CHURCH'S CH
PROTOTYPE
1,850 GROSS
FFE = 5027

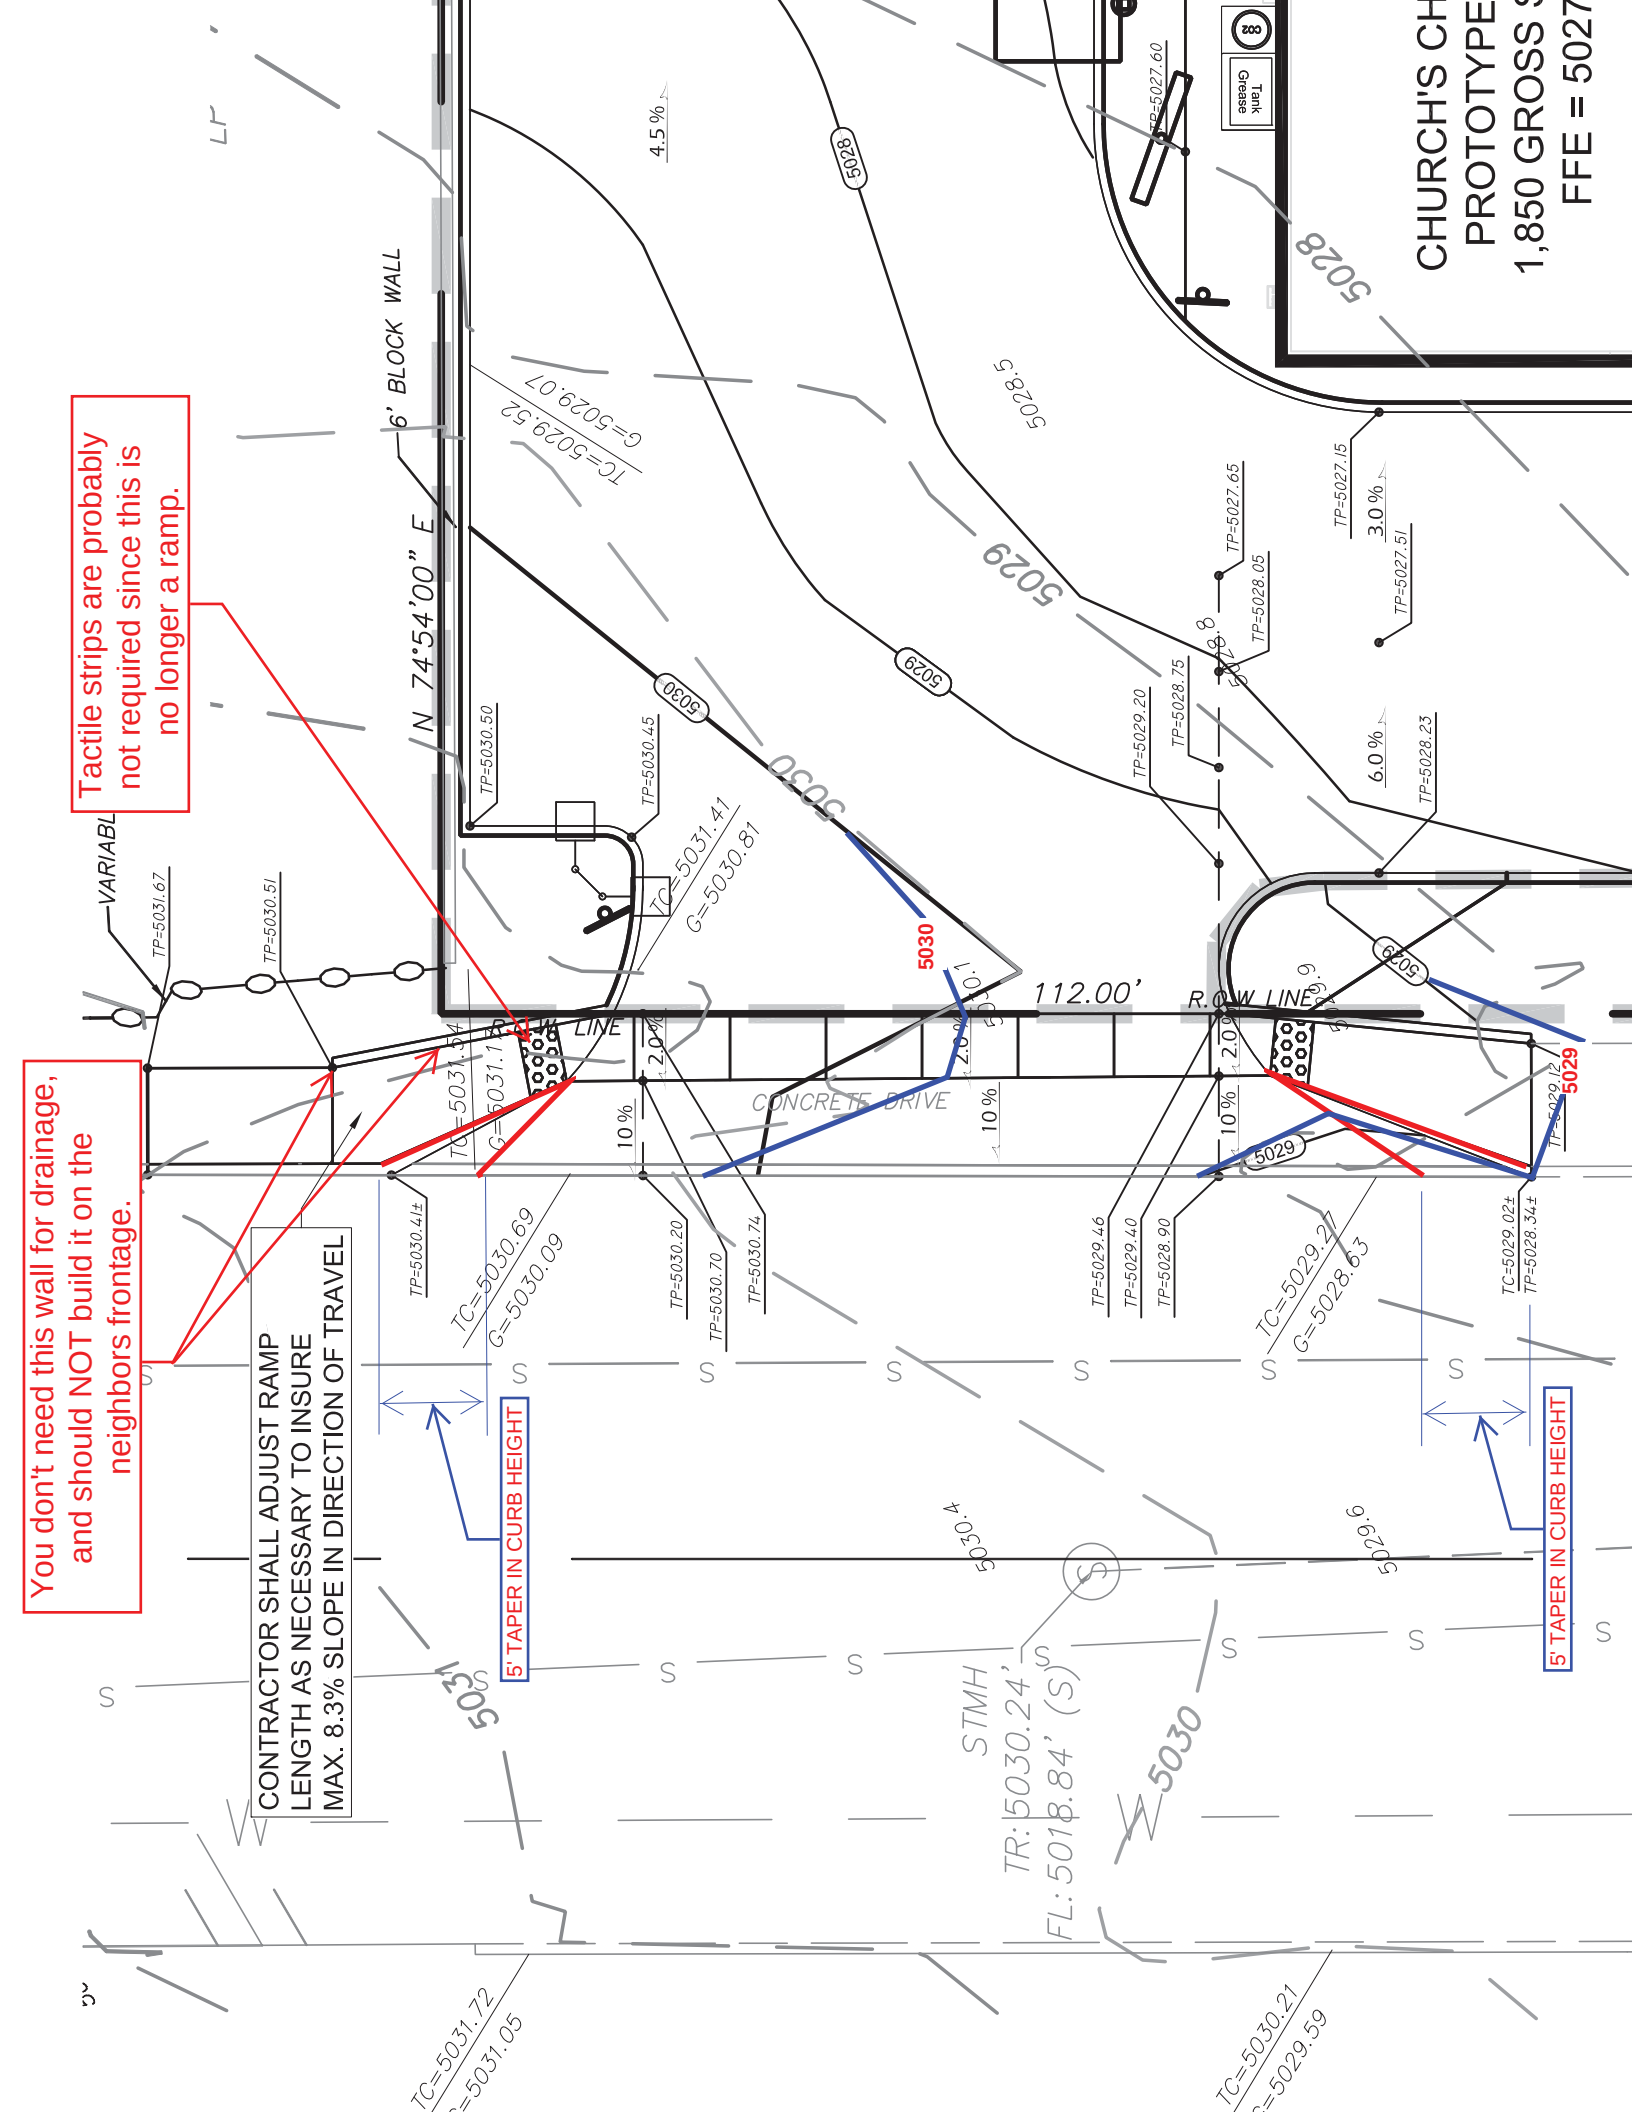
You don't need this wall for drainage, and should NOT build it on the neighbors frontage.

Tactile strips are probably not required since this is no longer a ramp.
